Access Compliance Report

Public Rights-of-Way

(Curb Ramps)

Intersection ID: 50339	Main Street: CASTLECOVE_RD	Cross Street: PAISLEY_ABBEY_LN	Location: NW
ADA ID: 315D11E64B9B	Ramp Type: BlendTrans1	Initial Pass/Fail: Fail	Overall Compliance: No
Severity Score: 21.25			
Codes/Mitigation Info/Possible Solution		Field Measurements/Component Compliance

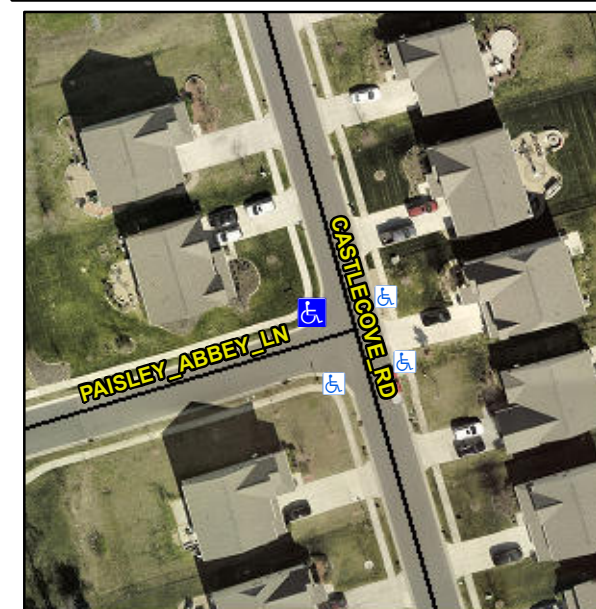
R304.5.1, R304.5.3

Compliance	Description	Data	Compliance	Description	Data
N/A	Ramp Length (in)	47.0	Yes	BlendTrans Slope (%)	1.1
No	Ramp Width (in)	47.5	No	BlendTrans XSlope (%)	5.2
N/A	Flare Type LT	N/A	N/A	Flare Type RT	N/A
N/A	Flare Slope LT (%)	N/A	N/A	Flare Slope RT (%)	N/A
N/A	Flare Traversable LT?	N/A	N/A	Flare Traversable RT?	N/A
N/A	Landing Length (in)	N/A	N/A	DWS Provided?	N/A
N/A	Landing Width (in)	N/A	N/A	DWS Contrast?	N/A
N/A	Landing Slope (%)	N/A	N/A	DWS Length (in)	N/A
N/A	Landing X Slope (%)	N/A	N/A	DWS Full Width?	N/A
N/A	Landing Curb? (Y/N)	N/A	N/A	DWS Offset (in)	N/A
N/A	Shared Landing?	N/A			
N/A	Gutter Ponding?	N/A	N/A	Gutter Slope (%)	N/A
N/A	Gutter Lip Ht (in)	N/A	N/A	Gutter X Slope (%)	N/A
N/A	Painted X Walk1?	No	N/A	Painted X Walk2?	No
	X Walk 1 Direction	To SE		X Walk 2 Direction	To NE
	X Walk 1 Width (in)	N/A		X Walk 2 Width (in)	N/A
	X Walk 1 Slope (%)	2.8		X Walk 2 Slope (%)	1.0
	X Walk 1 X Slope (%)	1.2		X Walk 2 X Slope (%)	5.9

Remove & Replace Curb Ramp With Two New Directional Ramps or Equivalent.
